**TENNESSEE VALLEY AUTHORITY**

November 29, 1985

TENNESSEE VALLEY AUTHORITY  
WATTS BAR NUCLEAR PLANT  
EMPLOYEE CONCERN PROGRAM  
NUCLEAR REGULATORY COMMISSION LISTING

# Memorandum

BREACHING TOOL

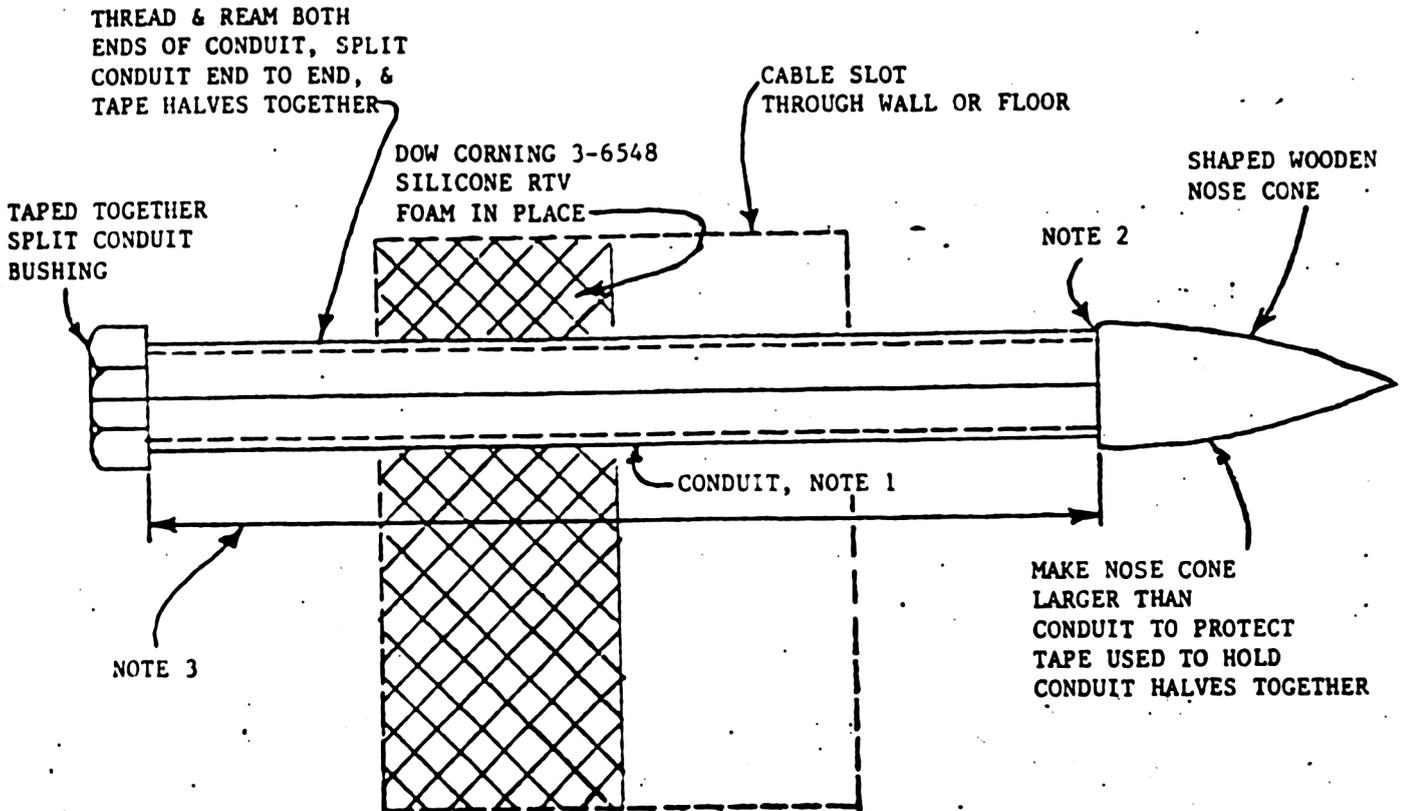
Remove Kaowool board or cut access holes as required. Breach the RTV foam in the cable sleeve with a clockwise motion using a tool as shown on attachment 7 (see attachment to this report). After removing the wooden nose cone, install a taped split bushing on the end of the conduit tool. Cables may be pulled through the breaching tool. Withdraw the breaching tool one inch from the face of the seal. Pack the hole between the tool and the face of the seal with Kaowool fiber. Inspect nozzle of application equipment through split conduit as breaching tool is withdrawn from penetration.

1. Review the breaching procedures, and either revise the procedures to permit additional tools to be used or confirm the existing ones to be adequate.
